December 9, 2022

**RE: Parkside at Carmel Apartments
7330 Carmel Ave NE
Grading and Drainage Plan
Engineer's Stamp Date: 12/6/2022
Hydrology File: C19D069A**

DRAWING NAME
GRADING & DRAINAGE PLAN

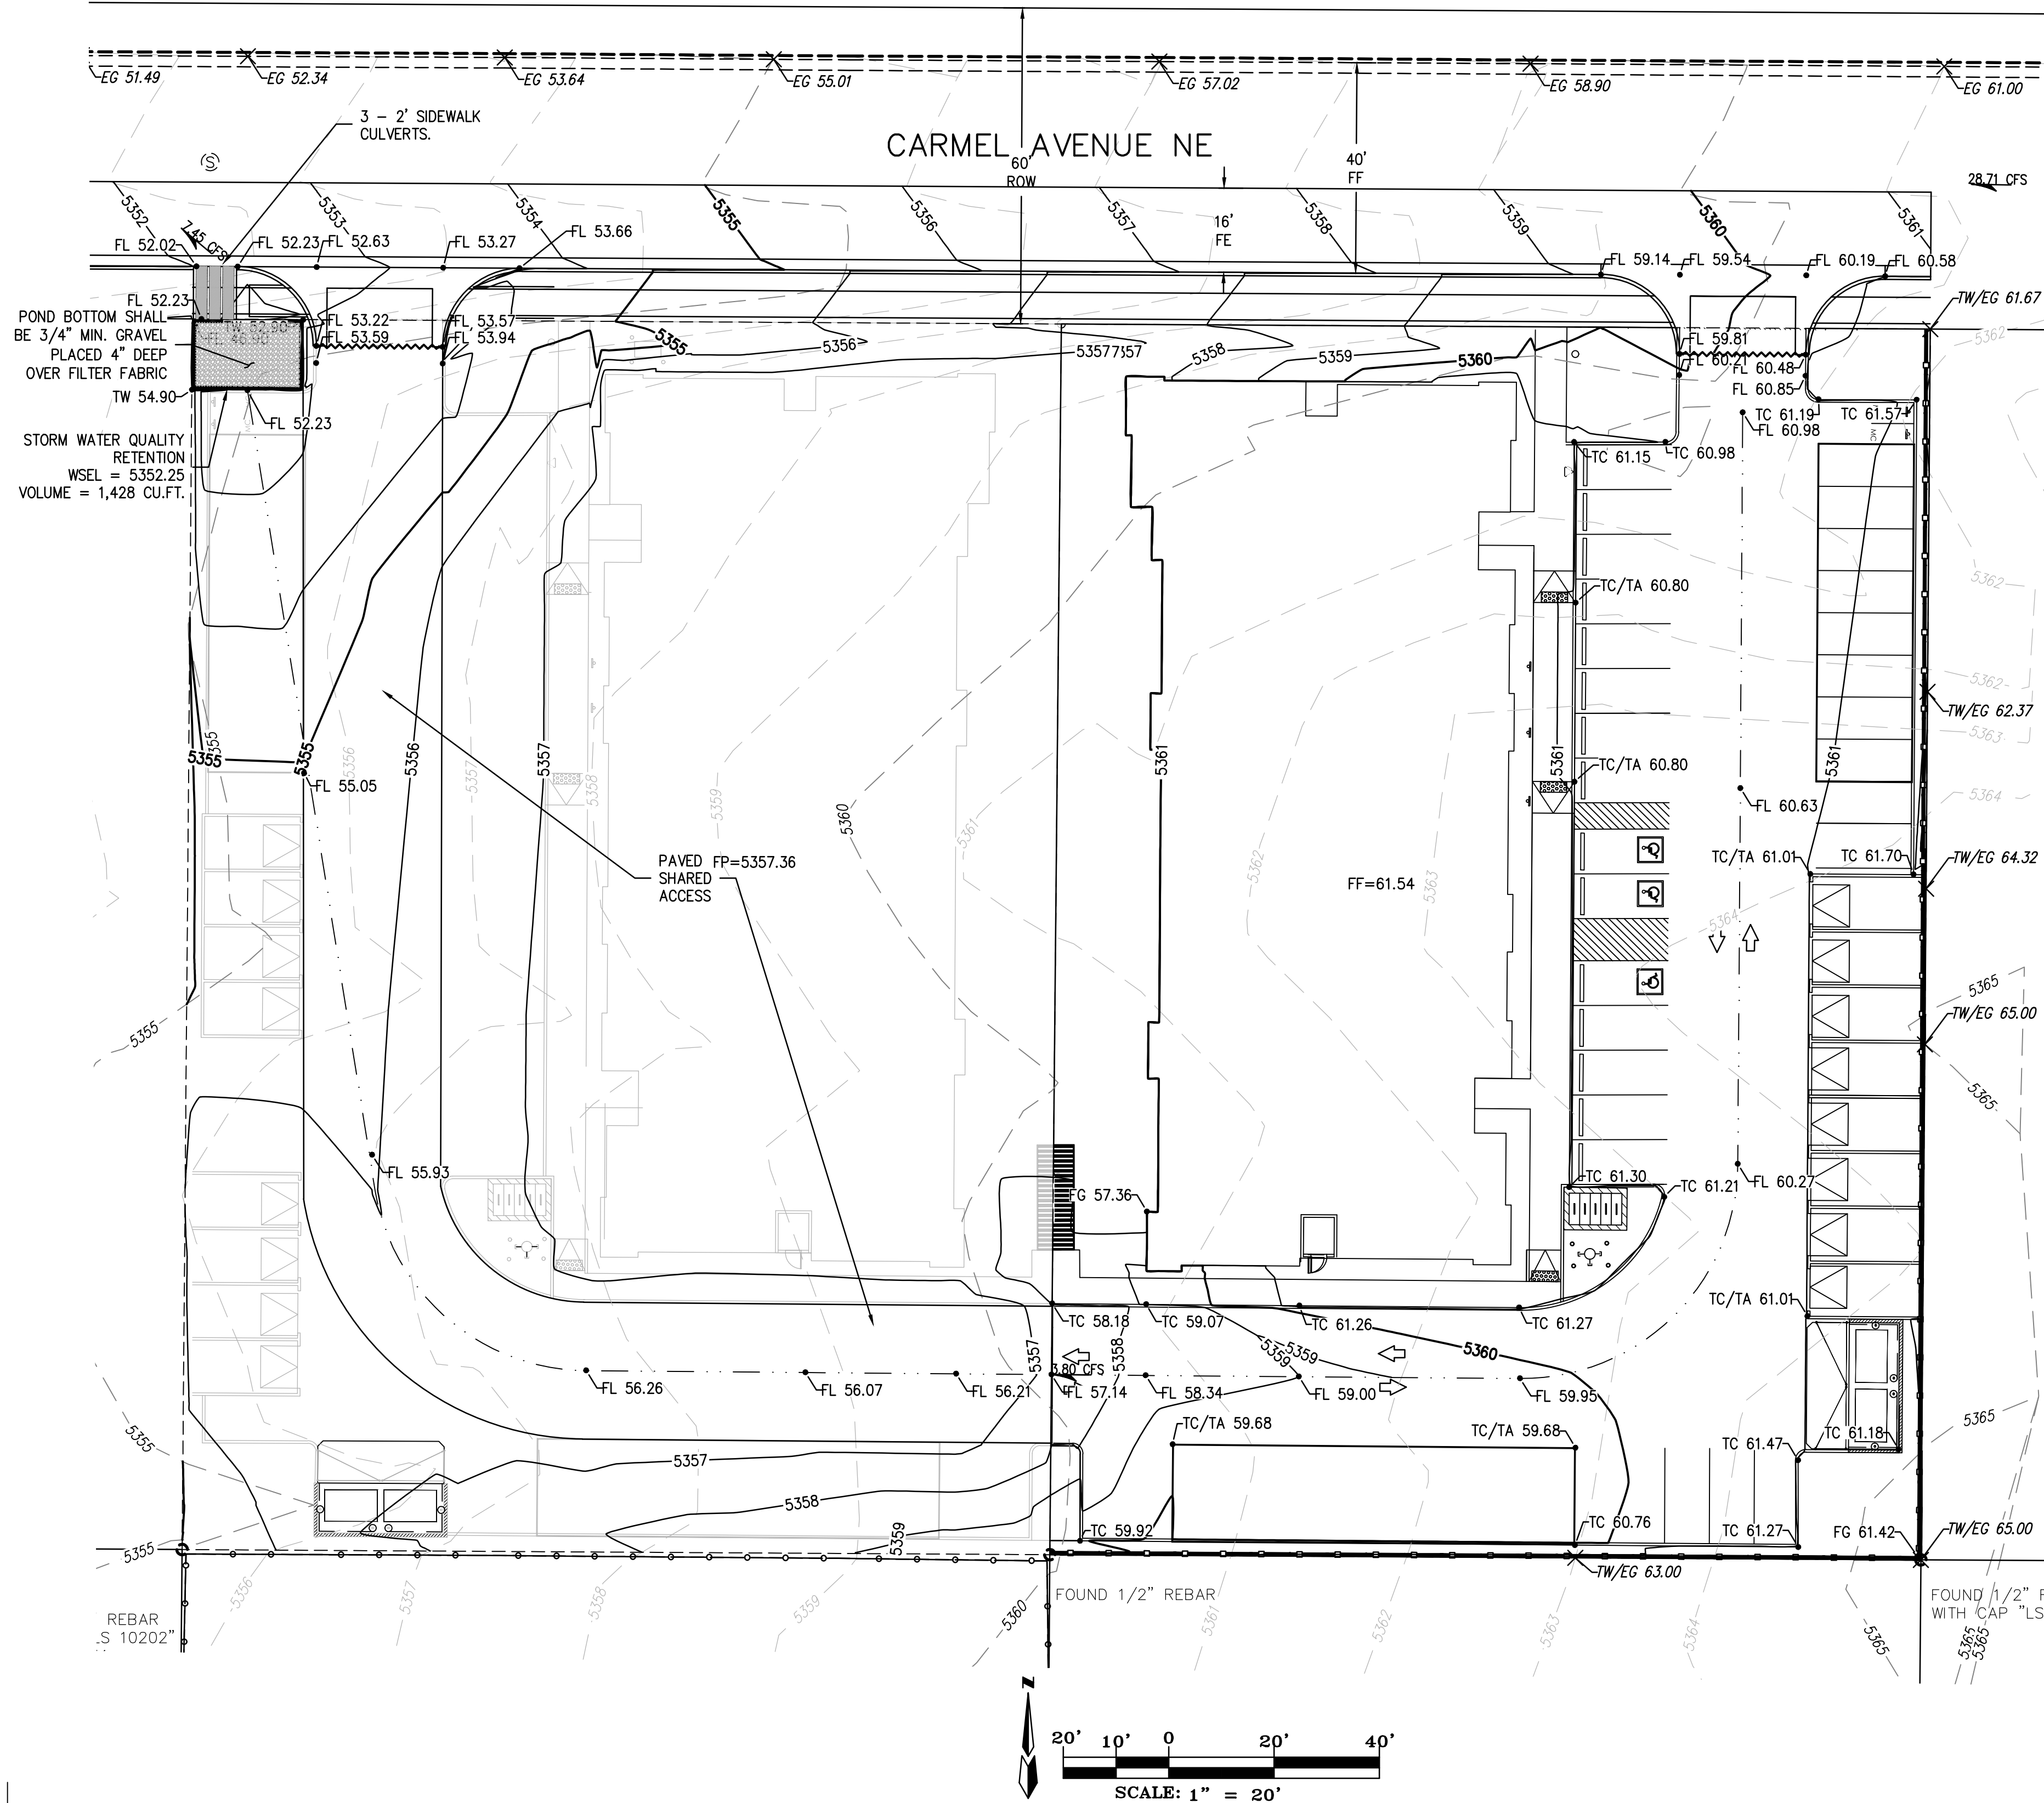
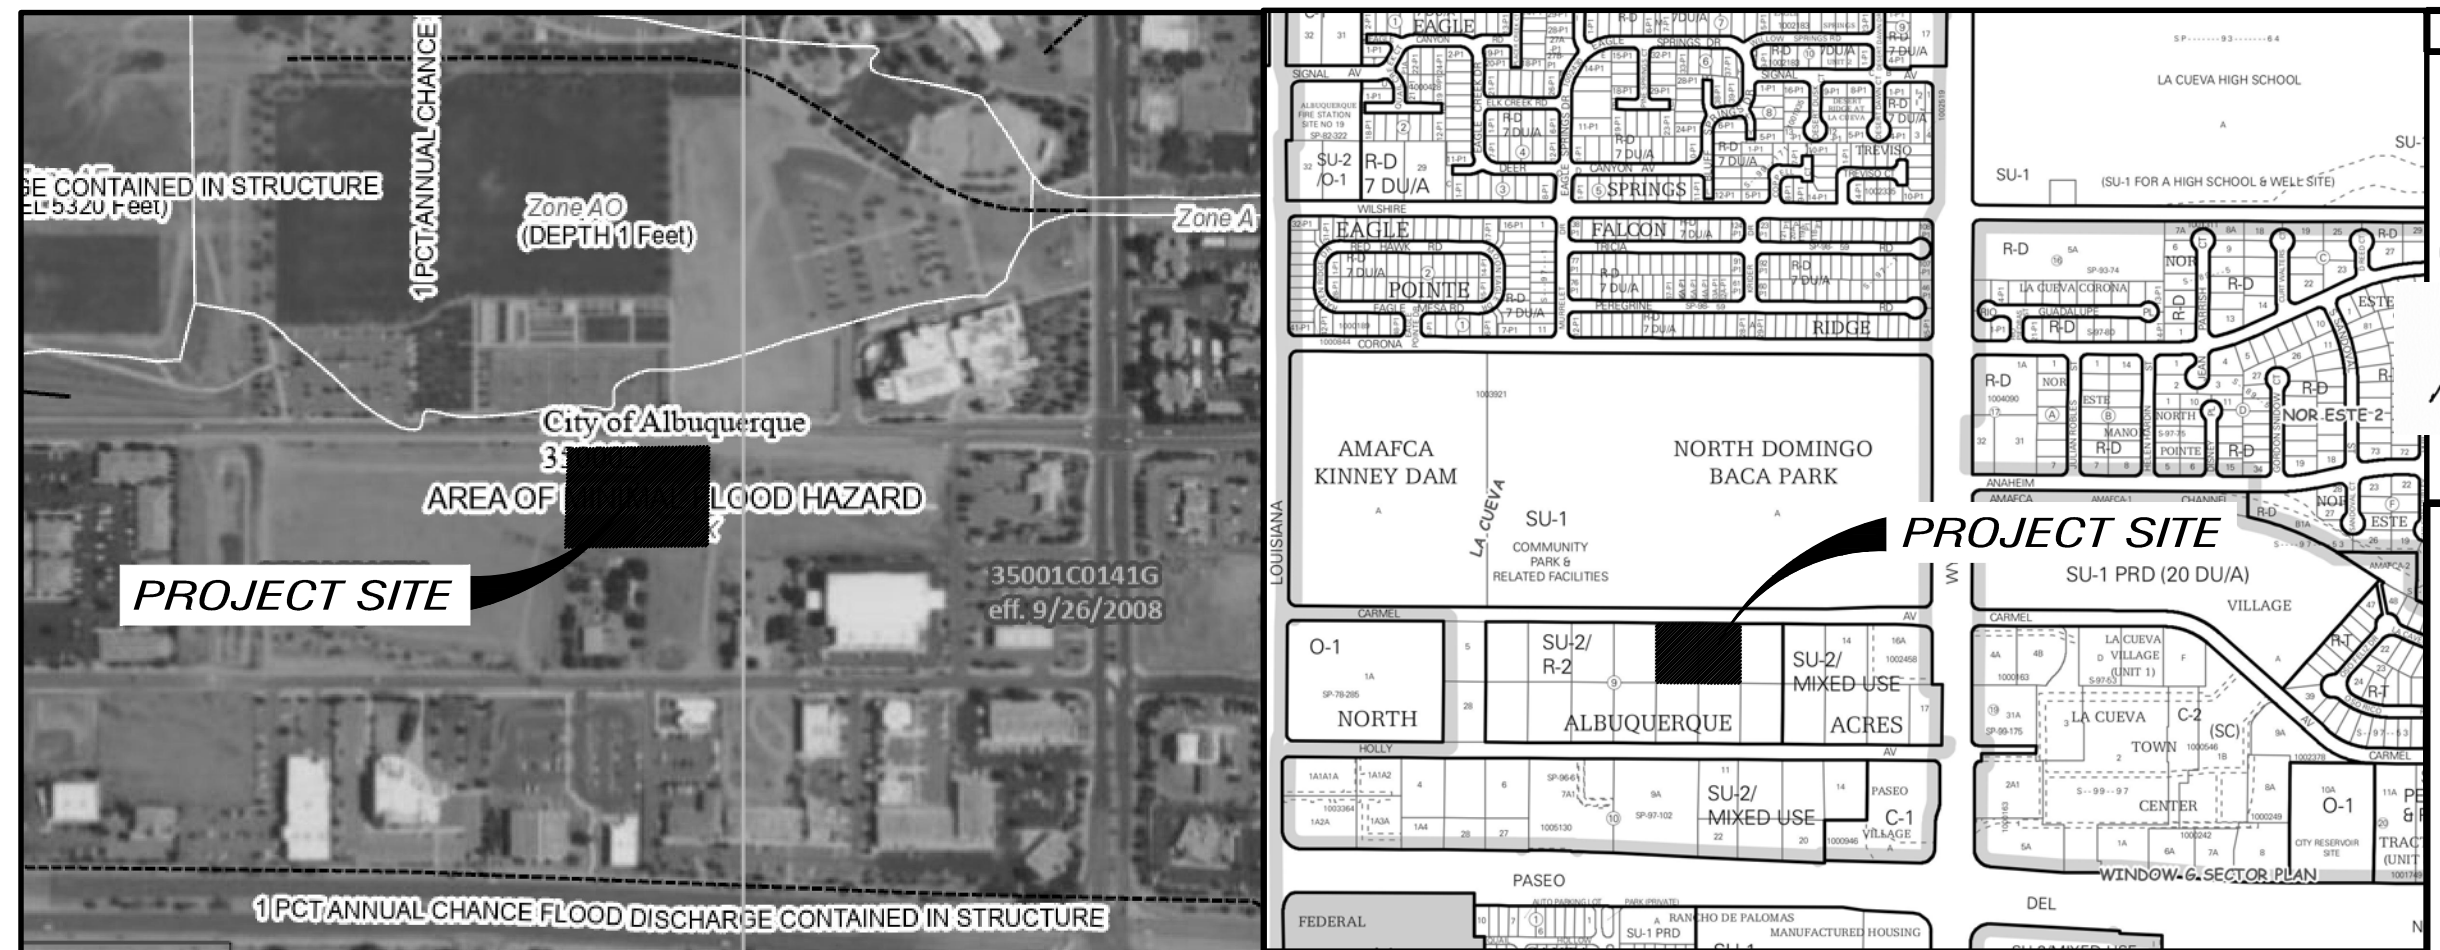
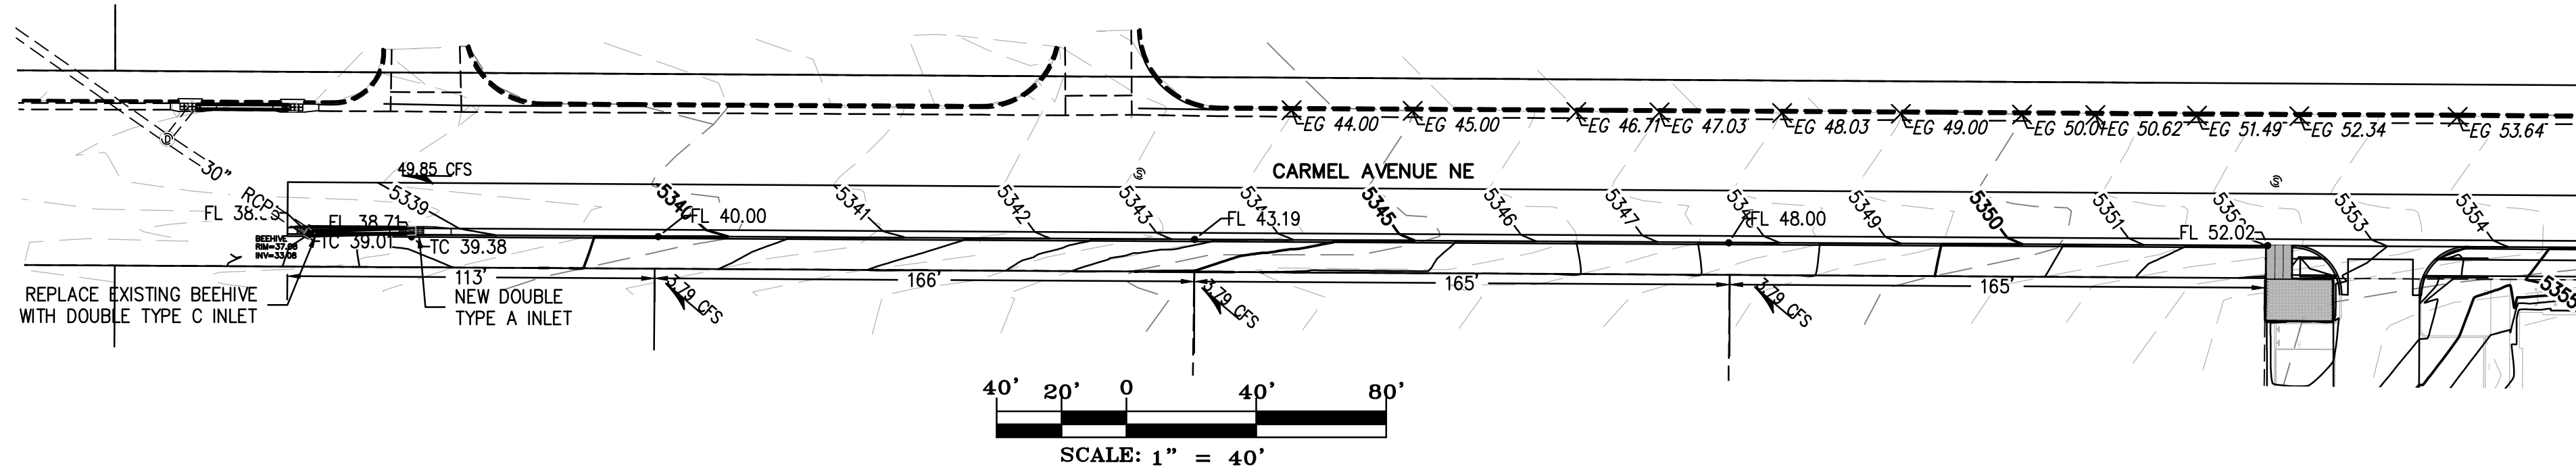
Based upon the information provided in your submittal received 12/6/2022, the Grading & Drainage Plan is approved for Grading Permit and Building Permit approval. Please attach a copy of this approved plan in the construction sets for Building Permit processing along with a copy of this letter.

1. Engineer's Certification, per the DPM Part 6-14 (F): *Engineer's Certification Checklist For Non-Subdivision* is required.
2. Please provide the executed paper Drainage Covenant (latest revision) printed on one-side only with Exhibit A and a check for \$25 made out to "Bernalillo County" for the stormwater quality ponds per Article 6-15(C) of the DPM to Hydrology for review. Once the review is done, Hydrology will send back an email stating our approval/comments.
3. Please pay the Payment-in-Lieu of \$ **6,960.00** by emailing the attached approved Waiver Application from Stormwater Quality Volume Management On-site to PLNDRS@cabq.gov. Once this is received, a receipt will then produce and email back with instructions on how to pay online. Once paid, please email me proof of payment.
